Well Name: PENNY 34/36 FED COM	Well Location: T22S / R26E / SEC 34 / NWSE / 32.348601 / -104.279482	County or Parish/State: EDDY / NM
Well Number: 716H	Type of Well: CONVENTIONAL GAS WELL	Allottee or Tribe Name:
Lease Number: NMNM96203	Unit or CA Name:	Unit or CA Number:
US Well Number: 3001554346	Well Status: Drilling Well	Operator: MEWBOURNE OIL COMPANY

Notice of Intent

Type of Submission: Notice of Intent	Type of Action: APD Change
Date Sundry Submitted: 12/15/2023	Time Sundry Submitted: 07:58
Date proposed operation will begin: 12/20/2023

Procedure Description: Mewbourne Oil Company requests permission to: Change the name of the GAMBINO FEDERAL COM 2H (API # 30-015-54346) to the PENNY 34/36 FED COM 716H Perform offline cementing and BOPE break testing as detailed in the attached documents See attached C102 and variance documents

Figure 1. Cactus 13 3/8" 5M offline cementing tool. Pressure rating limited by the lesser of 5M tool rating or the 13 3/8" pup joint and casing.

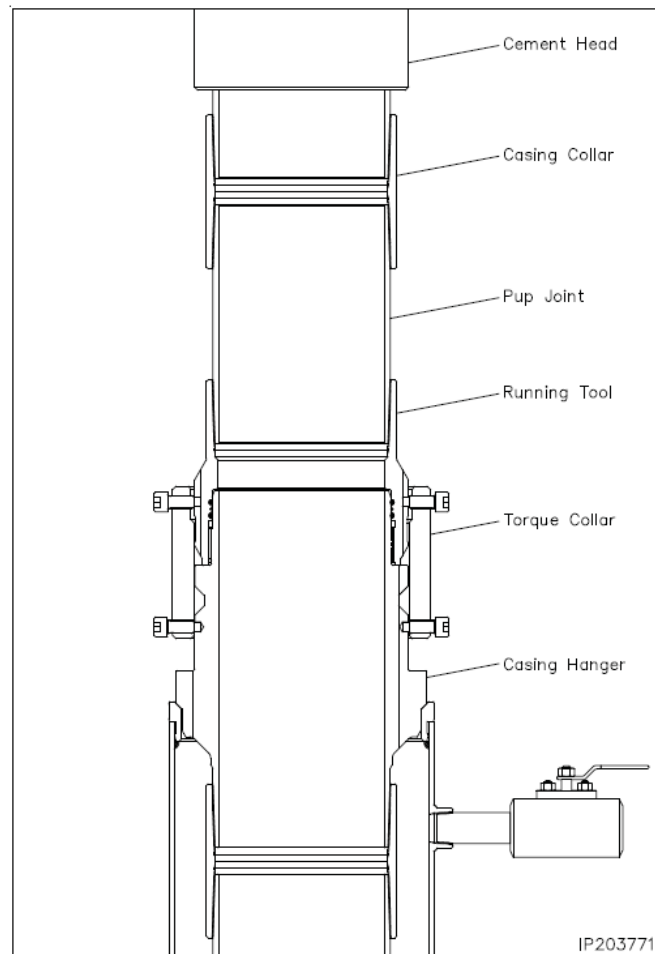
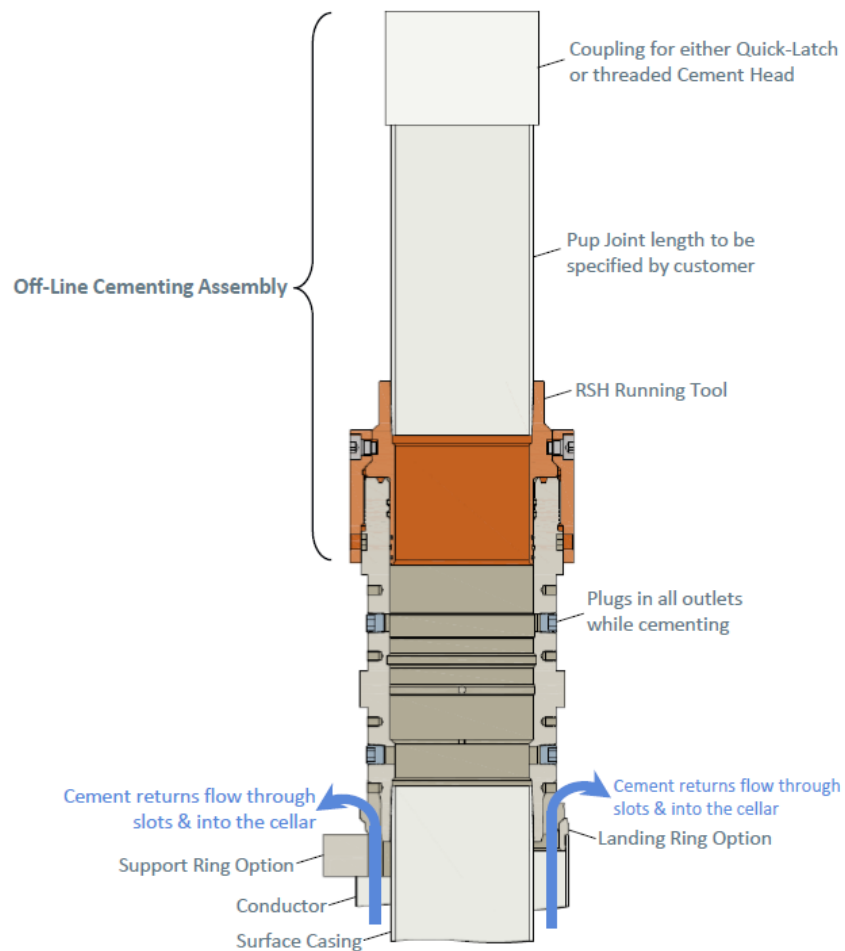
9. Make up offline cement tool with forklift per wellhead manufacturer (Fig. 1 & 2).
10. Make up cement head on top of offline cement tool with forklift.

Figure 3. Cactus 9 5/8" 5M offline cementing tool. Pressure rating limited by the lesser of 5M tool rating or the 9 5/8" pup joint and casing.

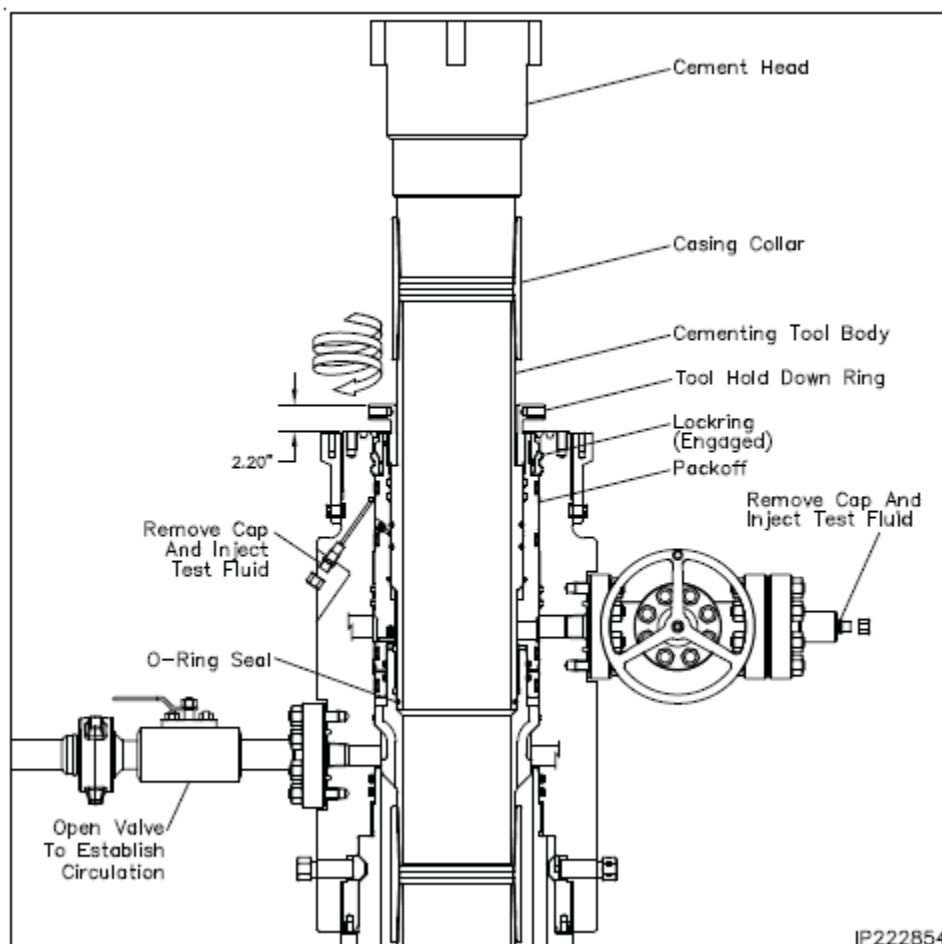
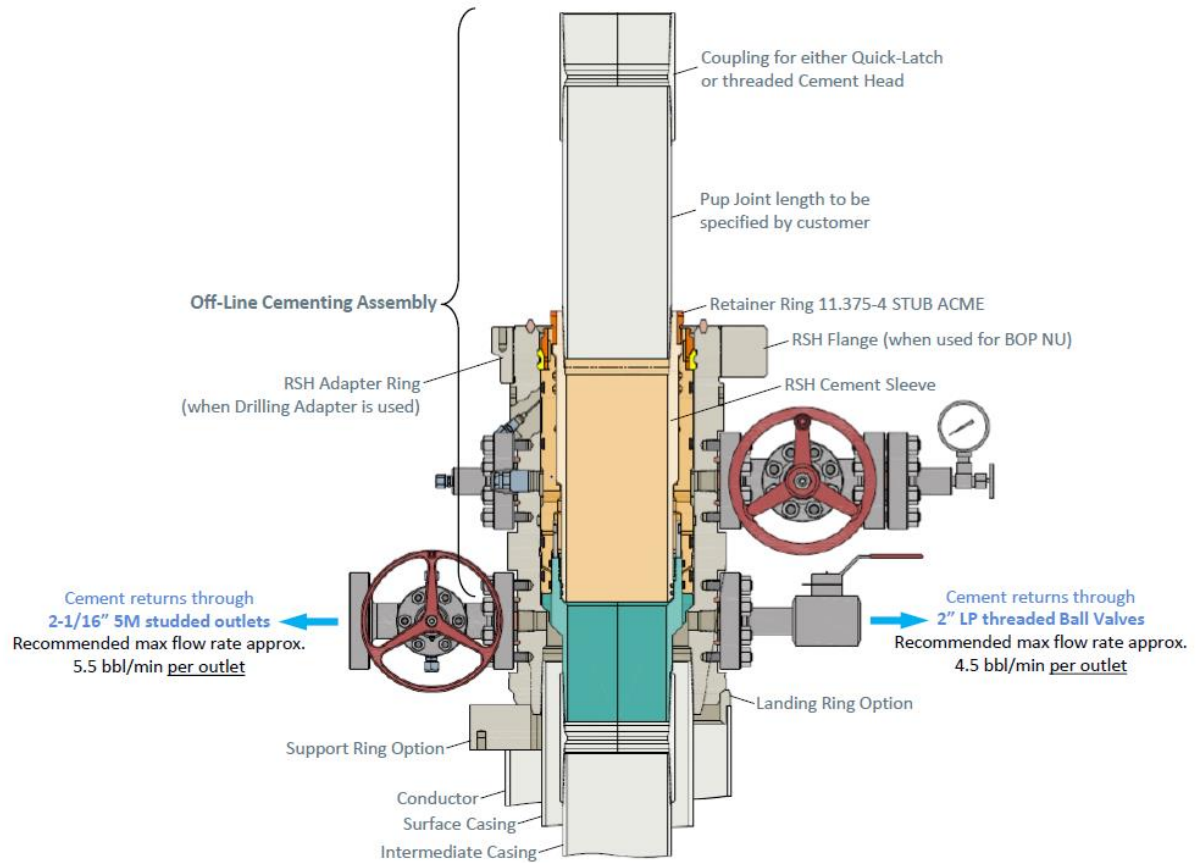
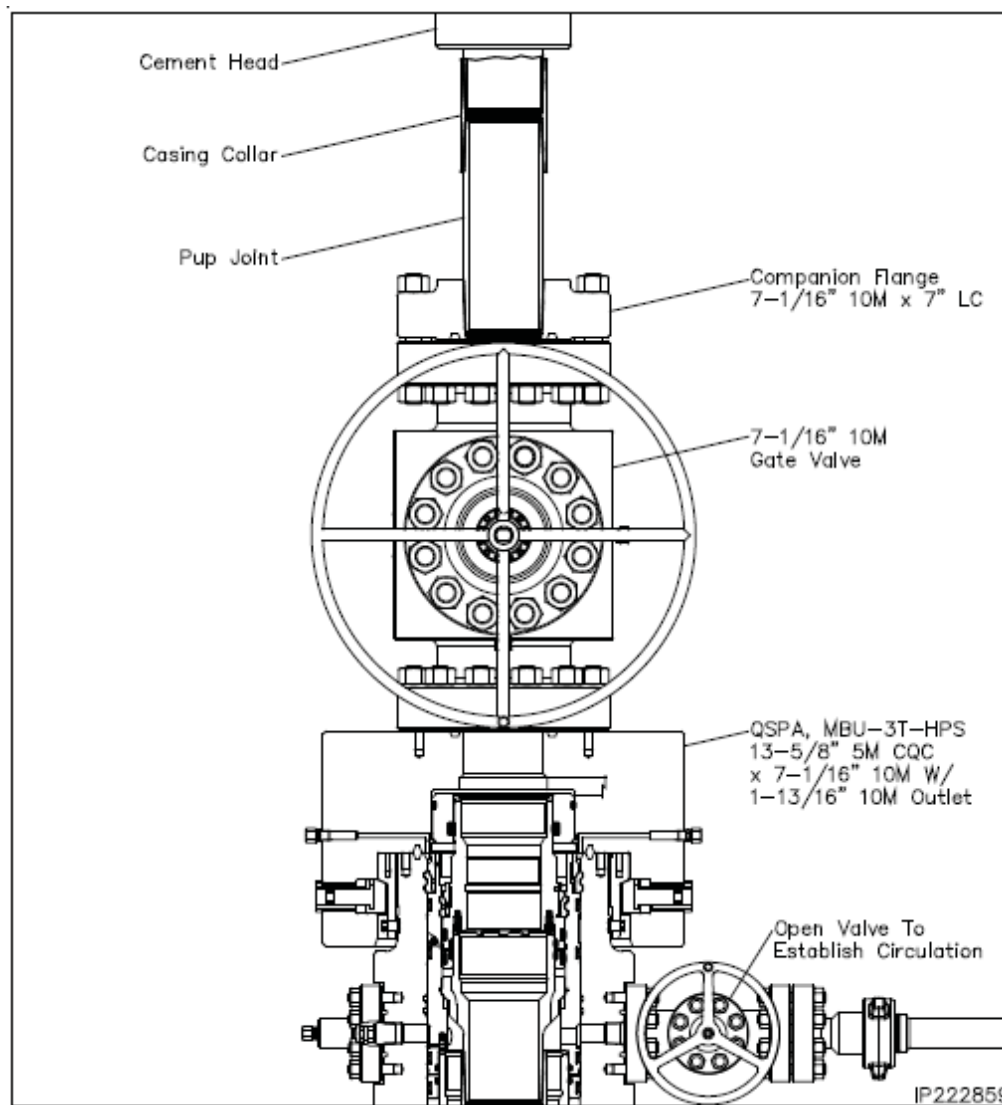
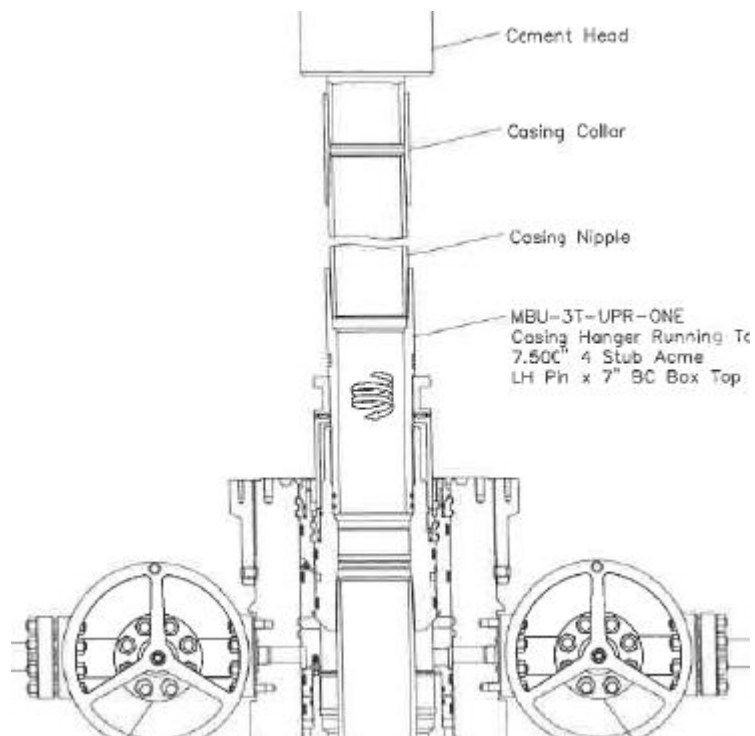
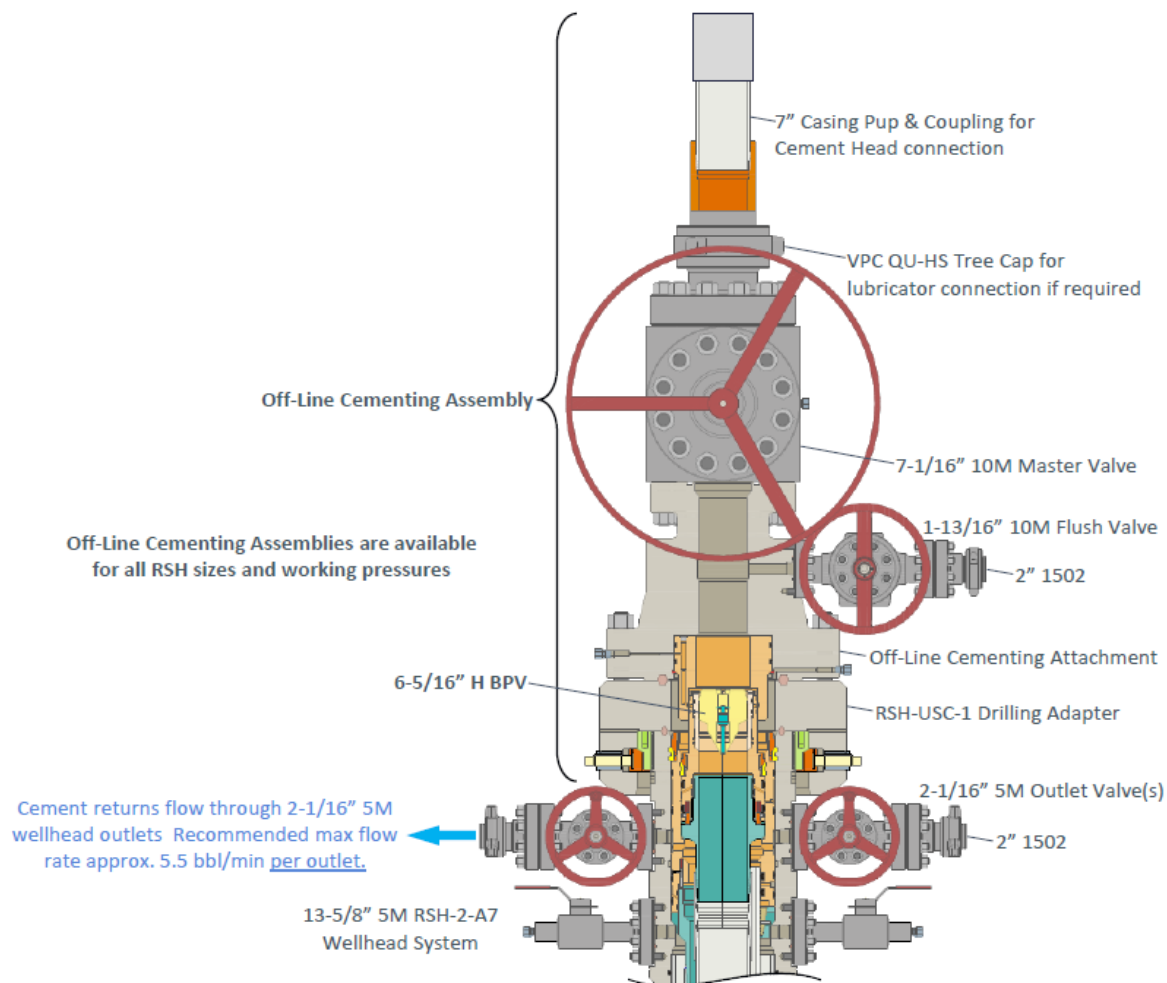
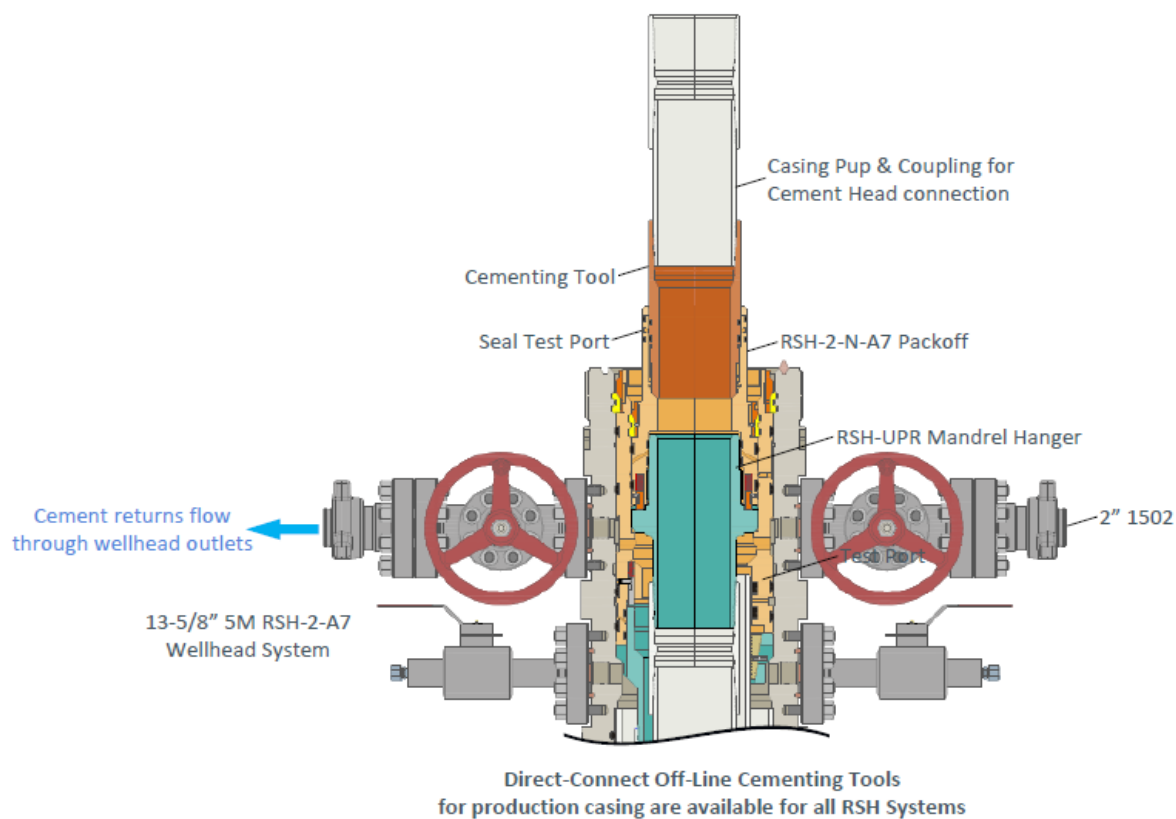
10. Make up offline cement tool using forklift per wellhead manufacturer (Fig. 3 - 8).
11. Make up cement head on top of offline cement tool.
12. Commence cement operations.

Figure 9. Five valve 15k choke manifold.

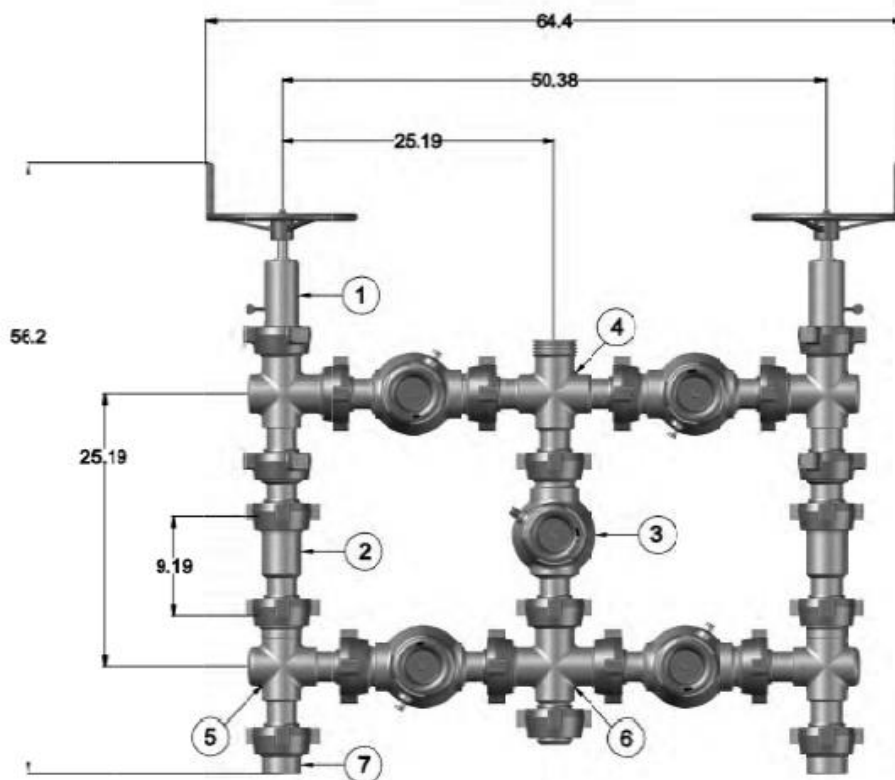
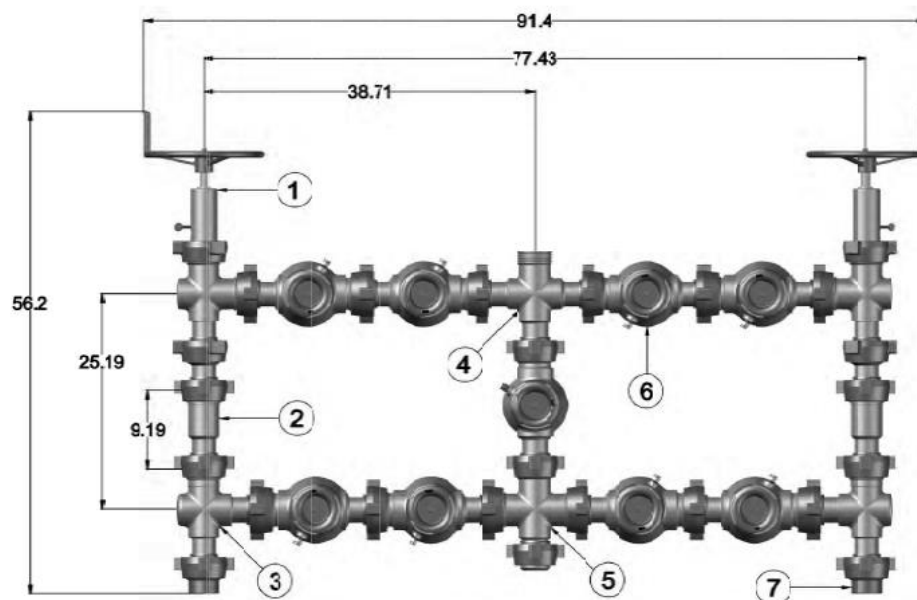
- Pressure build up in annulus before cementing
 - Contact BLM if a well control event occurs.
 - Rig up 3rd party pump or rig pumps to pump down casing and kill well.
 - Returns will be taken through the wellhead valves to a choke manifold (Fig 9 & 10).
 - Well could also be killed through the wellhead valves down the annulus.
